RE: PARC ADFER NOISE MODELLING

We are responding on behalf of WTI Limited to your email request dated 17th April 2015 for further information in relation to the noise modelling submitted in support of the Environmental Permit Application for the Parc Adfer EfW Facility.

Figure 1
Plant Layout & Internal Reverberant & Sound Power Noise Levels

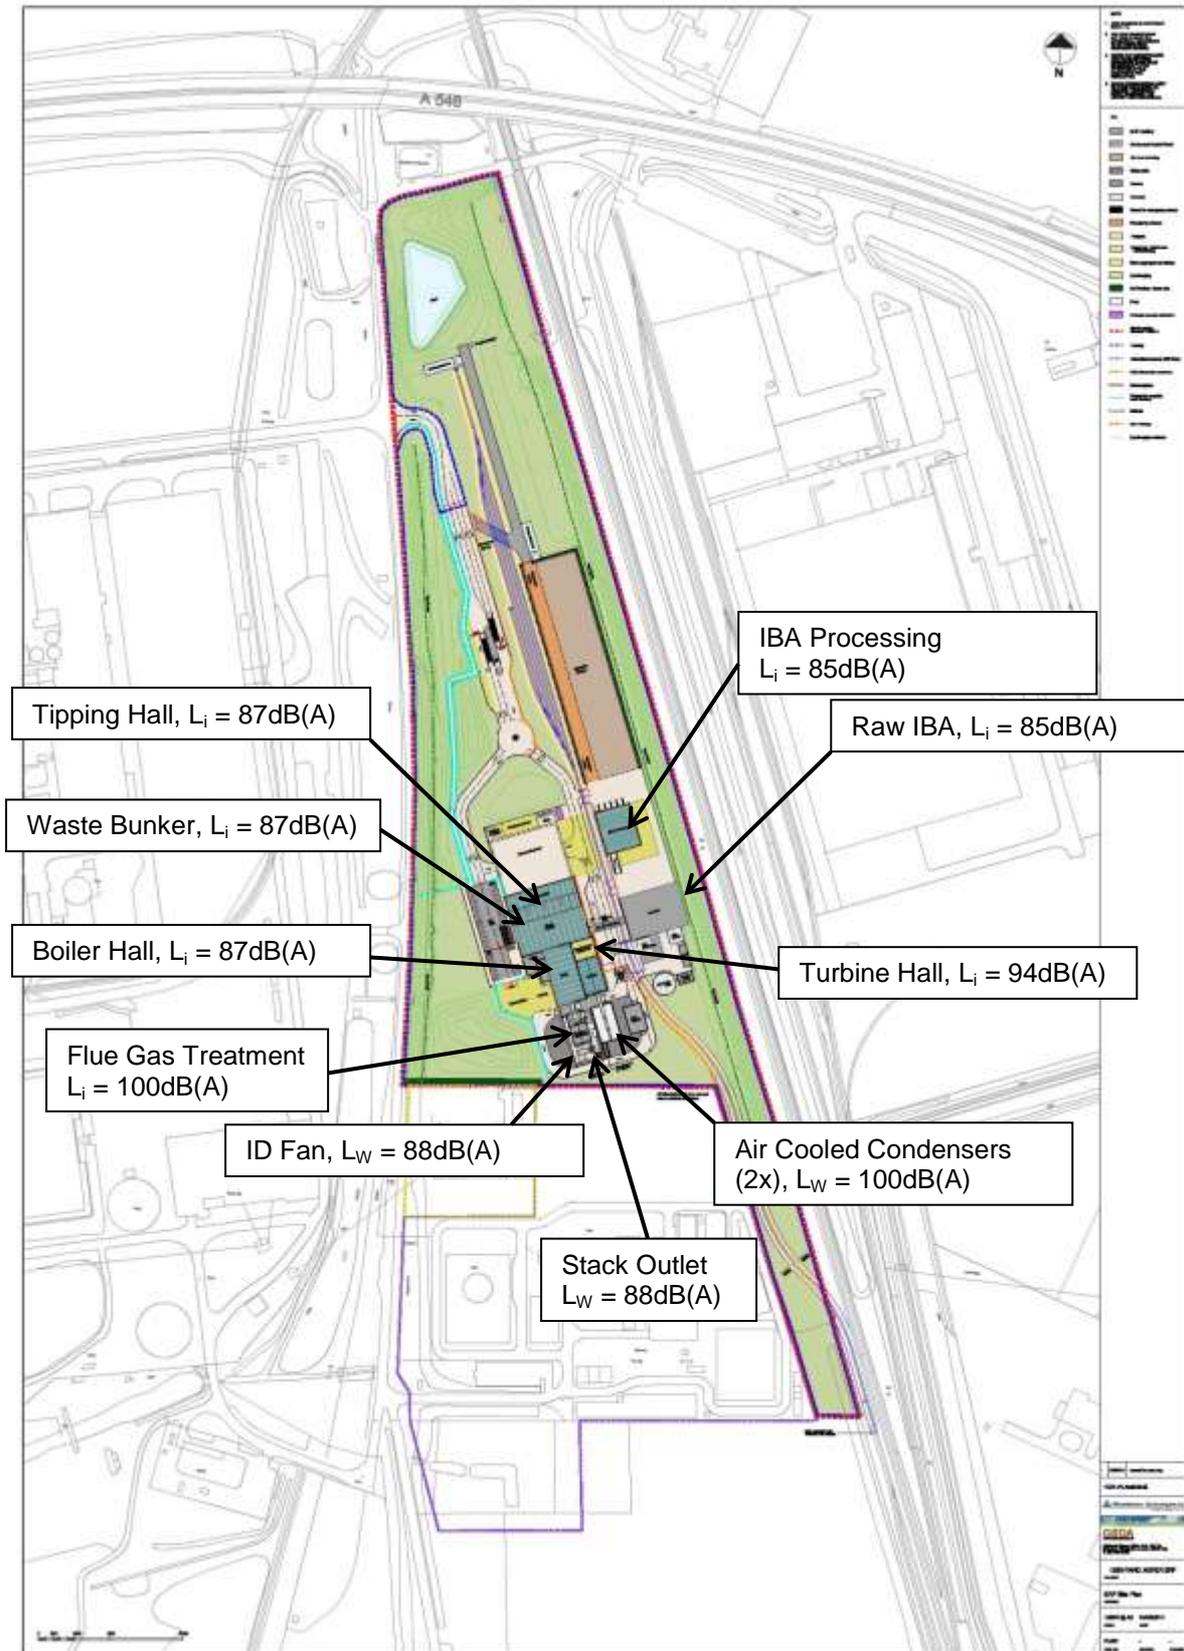
Please also provide a layout plan for the building detailing the location and sound power characteristics relevant to all processes described, full constructional details of sound insulation treatments should also be provided.

Figure 1 shows a layout of the building with the location and sound power characteristics of the relevant processes. Table 2 details the sound insulation treatments.

Figure 2
Plant Layout & Receptor Locations

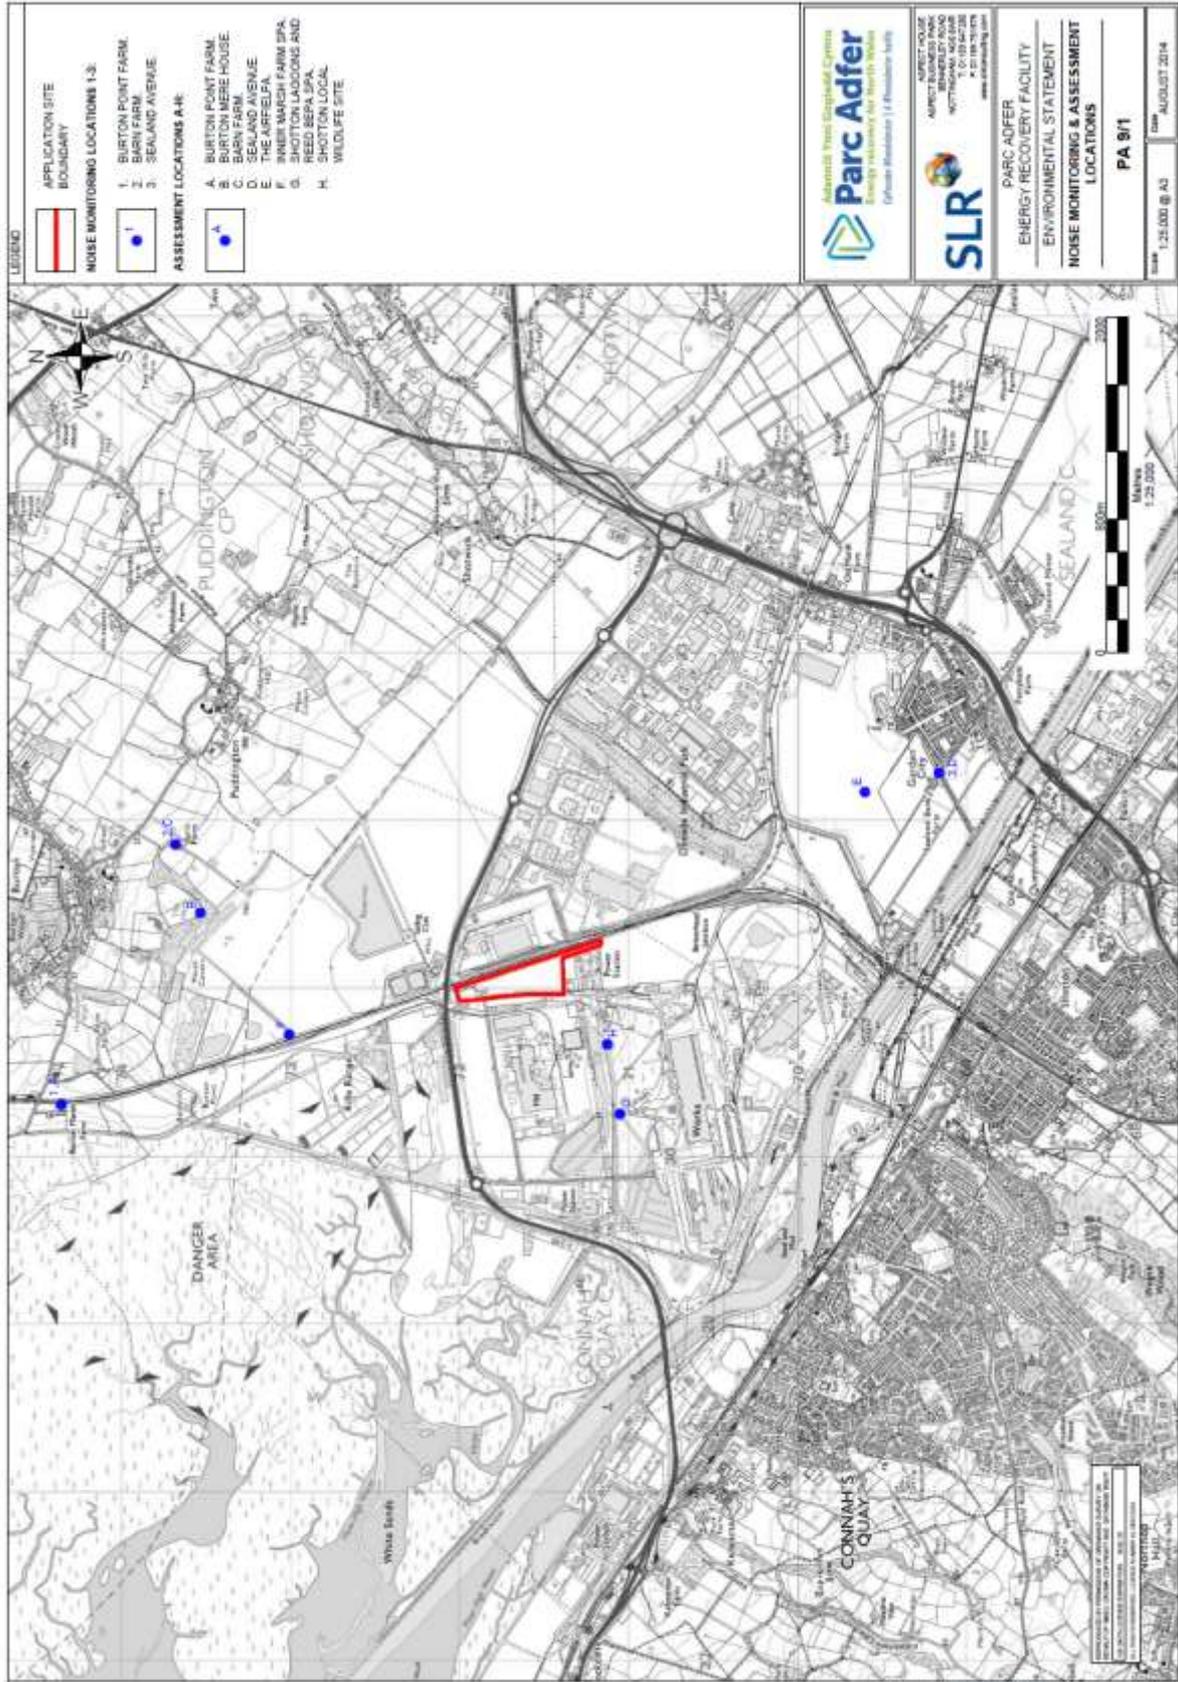
It would be useful for a plan to be provided showing the location of receptors in relation to noise. Please provide a plan showing the locations of receptors used for rating the potential noise nuisance in relation to the proposed facility.

A drawing showing the receptor locations in relation to the plant was included in the Noise Chapter of the Environmental Statement (Ref PA9/1). A copy of this drawing is included in Figure 2 overleaf.
